G.O., No. 829

Returning to the D.P. I. for revision the plans and estimates for the construction of a building for the accommodation of certain A. E. L. Mission schools at Guntur.

Note by the Consulting Architect to Government,
dated 17th November 1908:-

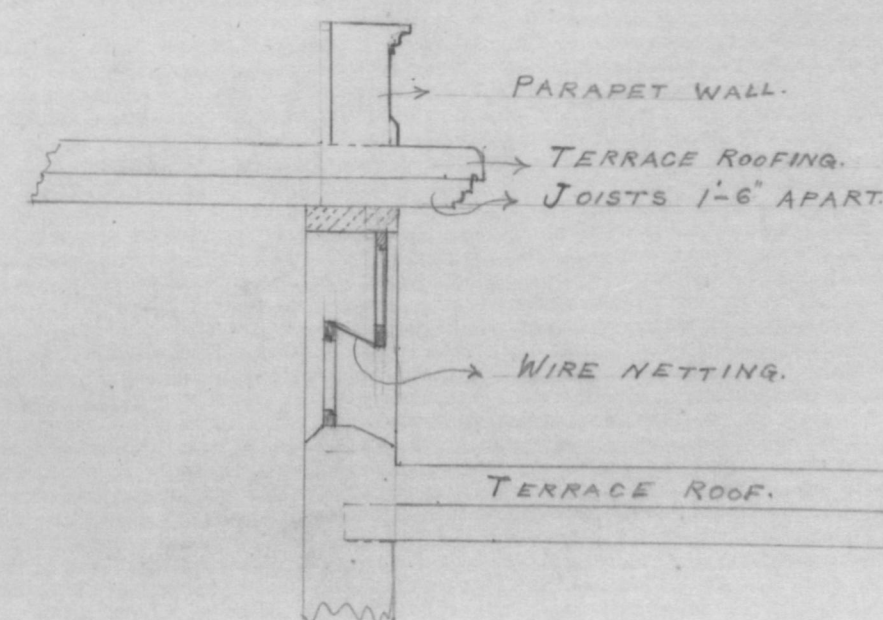
I submit that the plan should be returned to the Director of Public Instruction attention being called to the bad lighting of most of the rooms.

/ The plans should show which openings are meant for doors and which for windows. Clerestory windows should be more in number, and higher, cills being splayed downwards on ~~the~~ inside to admit light.

2 The height from verandah floor to underside of verandah roof might be 11 feet. The height from floor of class rooms to underside of class room roof might be 16' 6"; and the height from floor of Main Hall to underside of Main Hall roof might be 22 feet. This will admit the use of clerestory windows all round the Main Hall. Clerestory windows should be shaded, e.g. by projecting the terraced roof 2' 0" in advance of the outside of the wall

8 10
The type of clerestory window sketched above has been found satisfactory in similar cases. It obviates pulleys and ropes and always admits air without rain.

3. The elevation does not agree with the plan (vide blue marks). Positions of all *RSJ* should be dotted on the plan, clerestory windows being arranged between them.

4 Some of the arches at corners of verandah have no abutment, judging from the ground plan.

The plans and estimate, received with his letter read above are returned to the D.O. I for revision ^{with reference to the} ~~in accordance with the~~ Consulting Architect's note of 17th November 1908; Copy of which ^{OR} is herewith forwarded.
18-12-08
